To: Plan Holders for SLN Terminal Expansion  
Salina Regional Airport  
Salina, KS  
AIP Project Number 2-20-0072-054/055-2024

Transmitted herewith Addendum No.2 to the Issued for Bid Contract Documents, Specifications and Plans dated July 2, 2024 for improvements to the Salina Regional Airport.

**ADDENDUM NO. 3**  
**TO**  
**CONTRACT DOCUMENTS, TECHNICAL SPECIFICATIONS, AND**  
**PLANS**  
**FOR IMPROVEMENTS TO THE**  
**SALINA REGIONAL AIRPORT**  
**SALINA, KS**  
**AIP PROJECT NUMBER 2-20-0072-054/055-2024**

SHEET NAME:  
ROOF PLAN

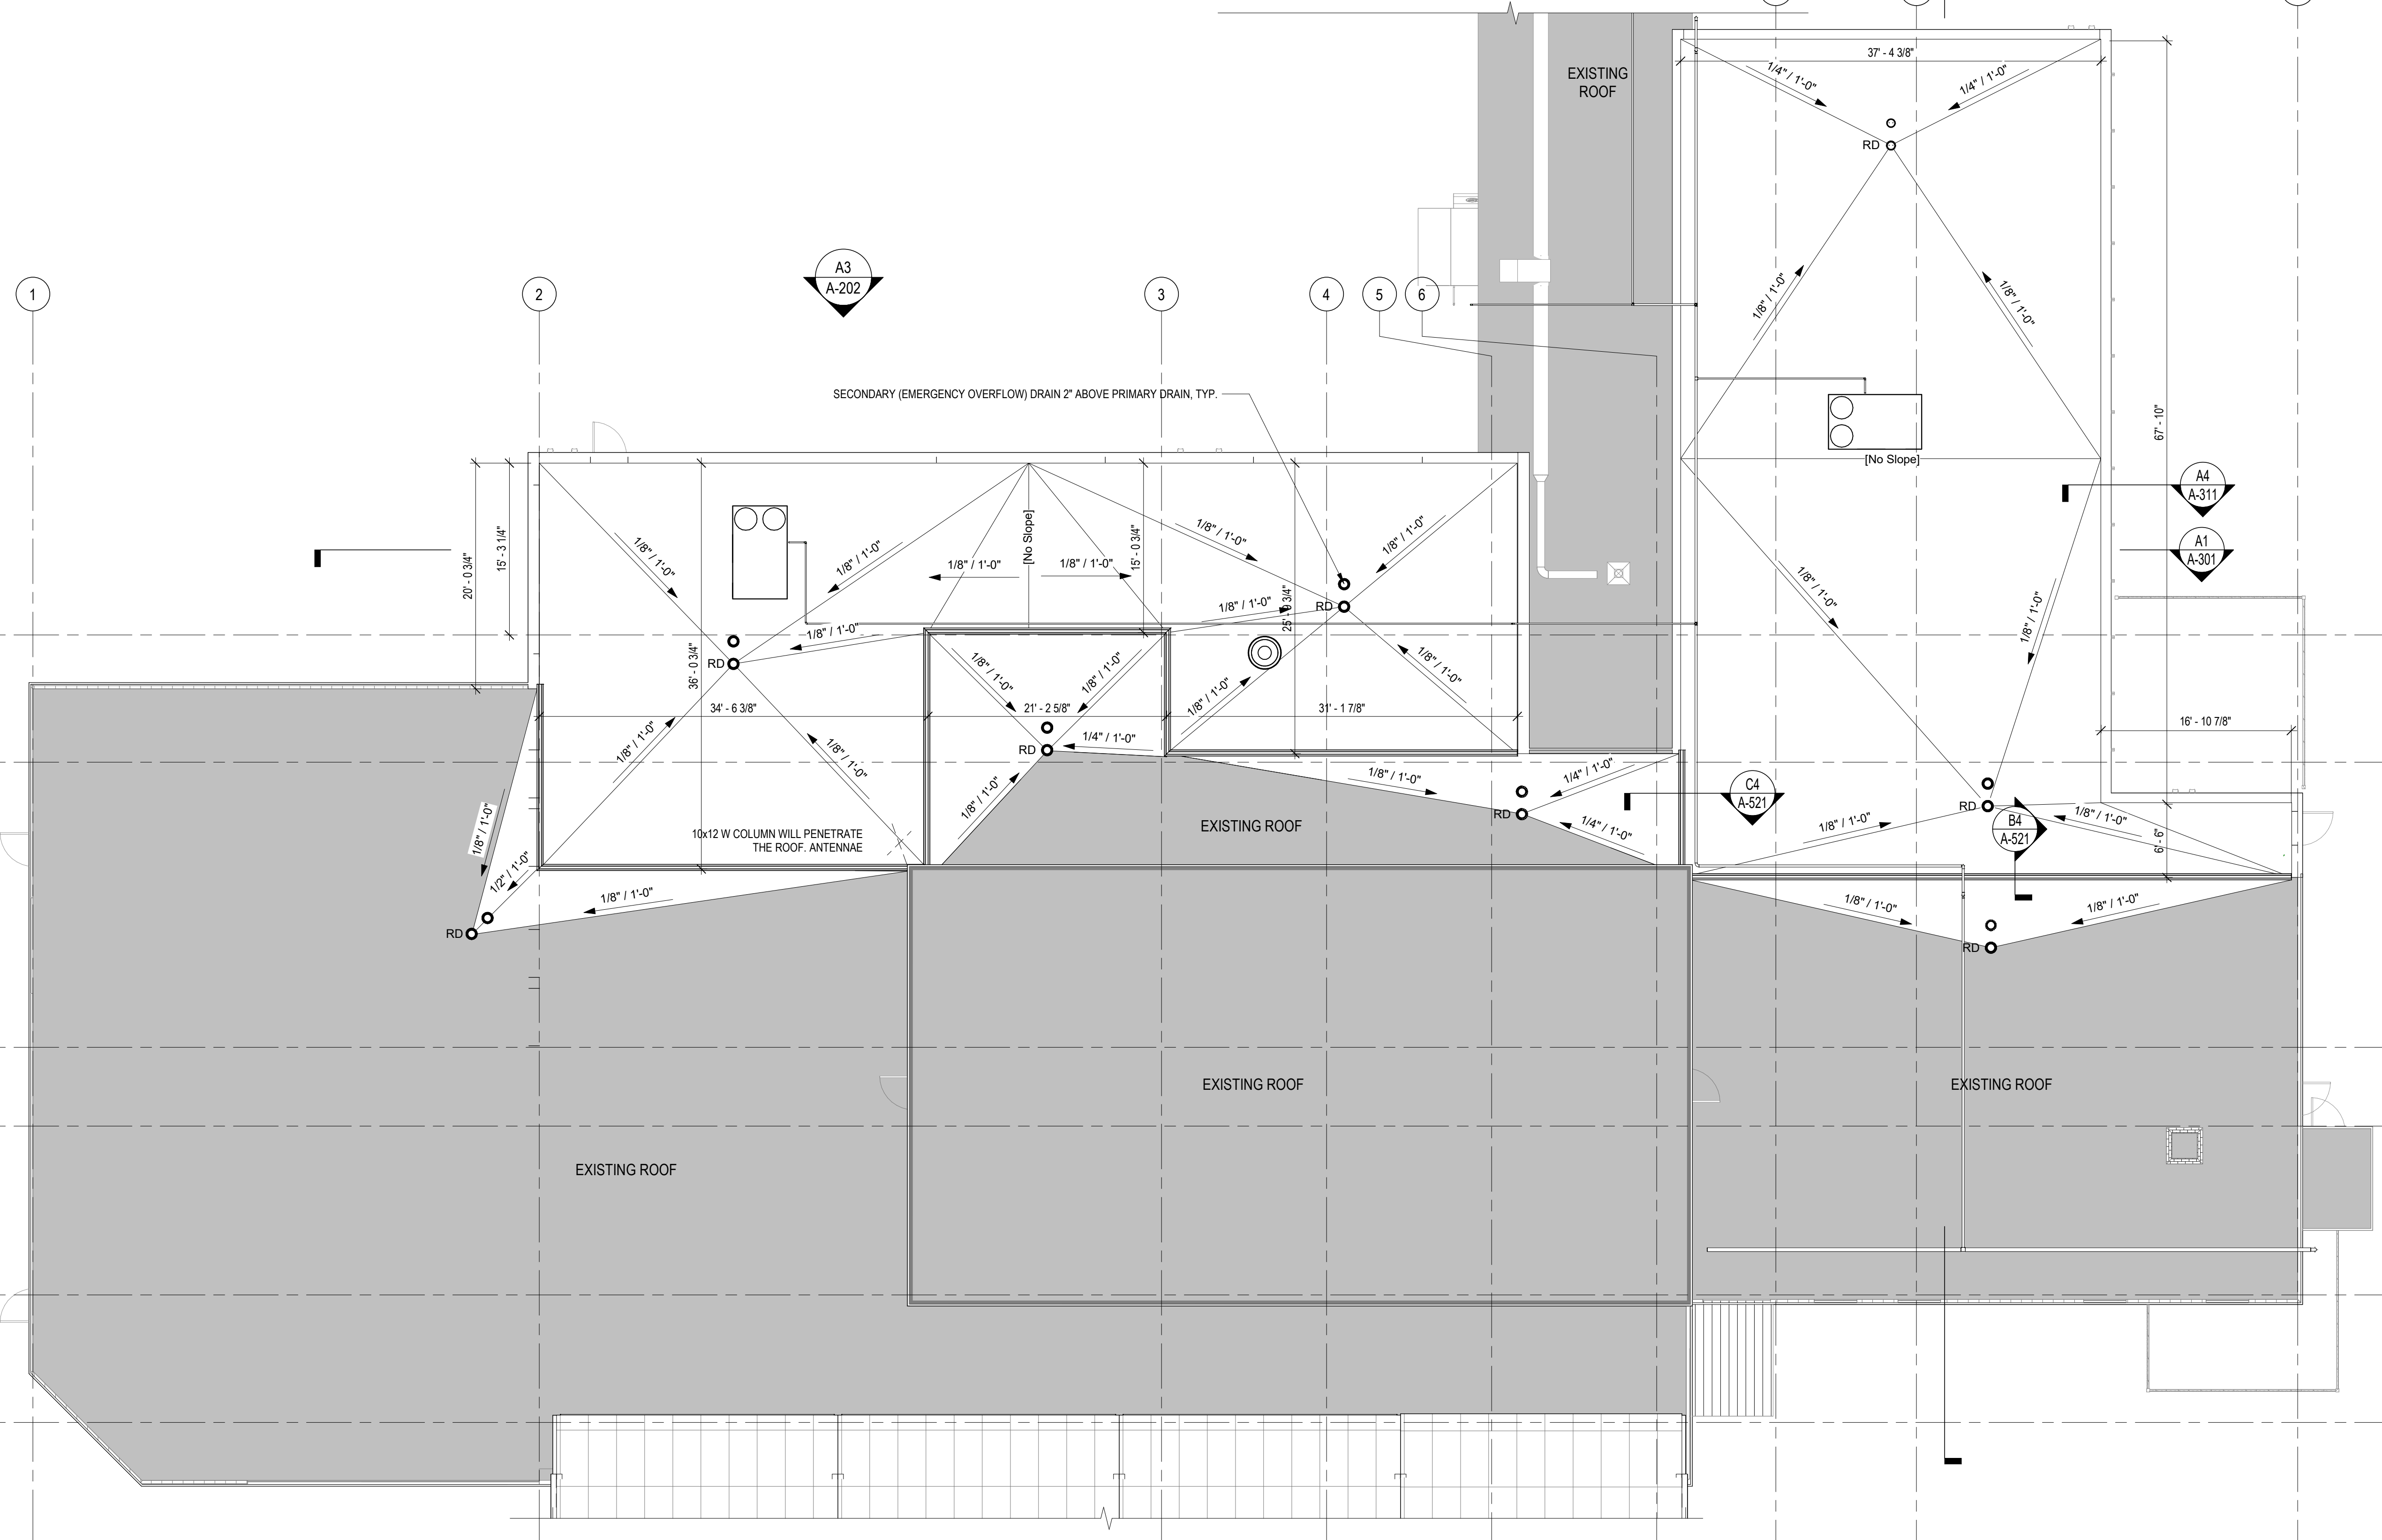
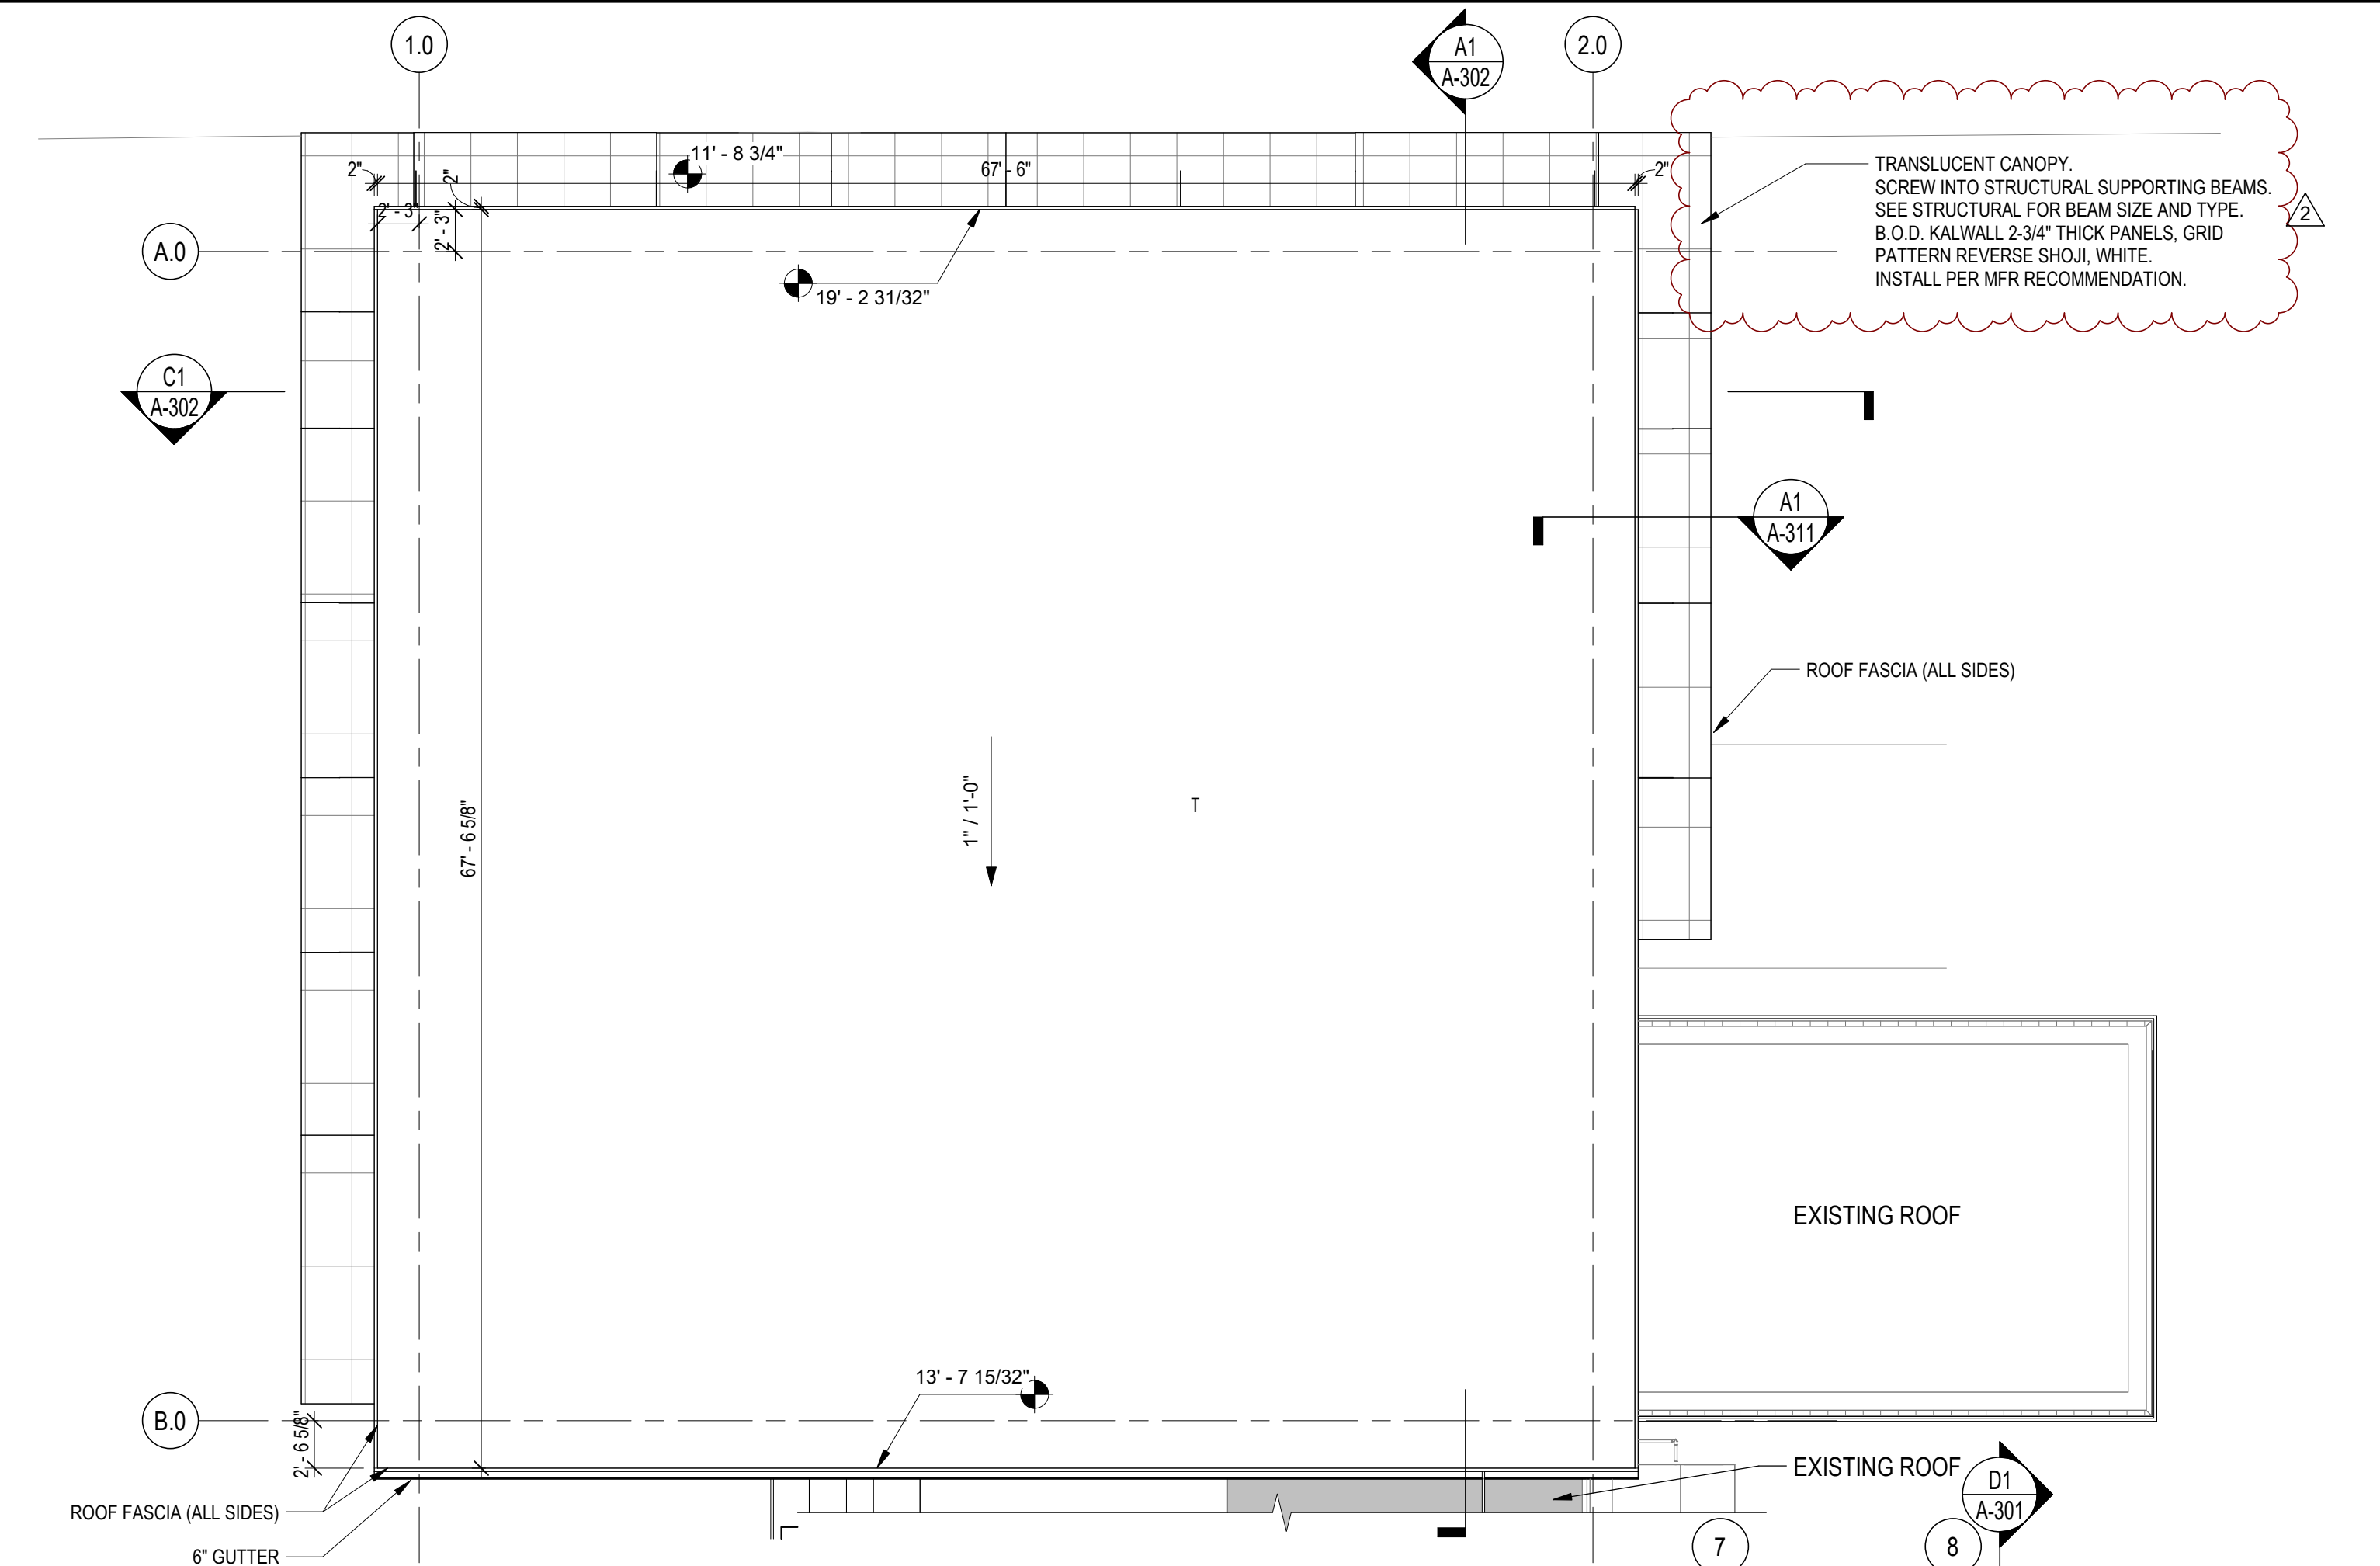
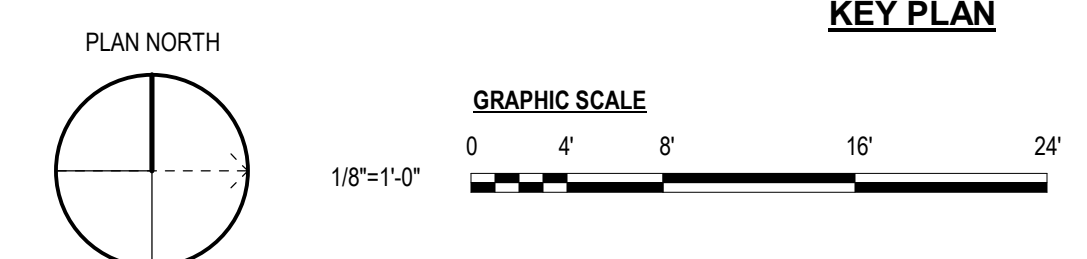
**A121 ROOF PLANS**

**Justification:** For clarification of Hold Room Canopy roof panel
